POST OCCUPANCY EVALUATION

ENDEAVOUR SCHOOL FLAGSTAFF, HAMILTON

April 2016

Date: April 2016
Reference: 1-46083.00
Status: Final

Figure 7

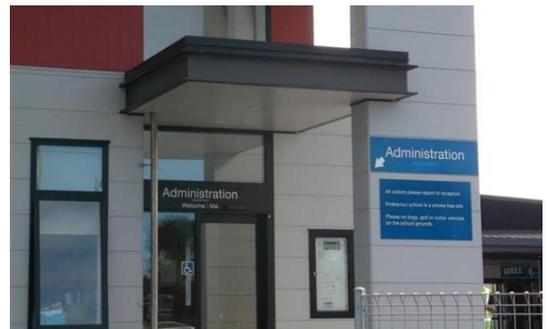
- The Principal commented that when the school initially opened reception and individual learning areas were not easily found by visitors to the site. The school has subsequently added more signage to improve wayfinding. Users in the school confirm this has been successful in solving the problem. See Figure 7.

Figure 25

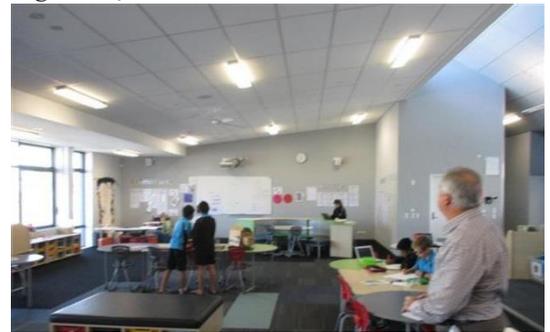
- The Principal indicated that the lighting system is good throughout the school. In particular, the system is efficient and does not create distracting glare in the learning spaces. See Figure 25.

Figure 32

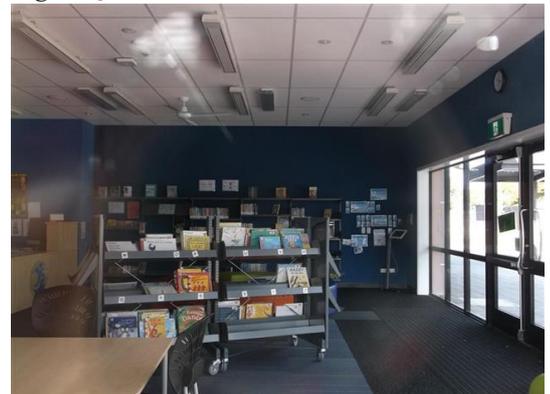
- The Principal considers the library too small both for their full catalogue, and for teachers to use as an additional teaching area.
- The Principal commented that lack of independent controls on the radiant heaters, as well as the number of radiant heaters in the space, has led to children overheating in the library, design room and gym spaces. See Figure 32 within the library, which gives a view to the number of radiant heaters installed.

Figure 33

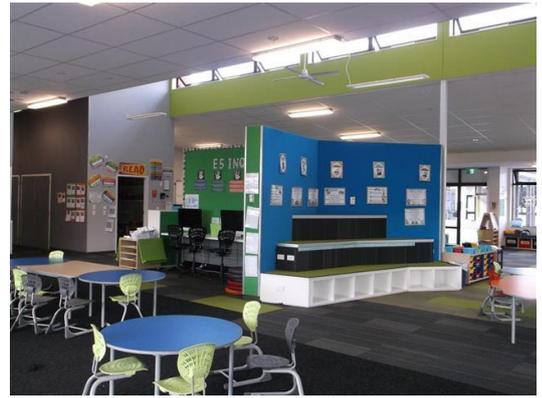
- Use of sound deadening Autex on the walls has been well received by users and is seen to be effective. The acoustic nature of the product and its flexibility as a pin or display board is welcomed by the teachers. See Figure 33.
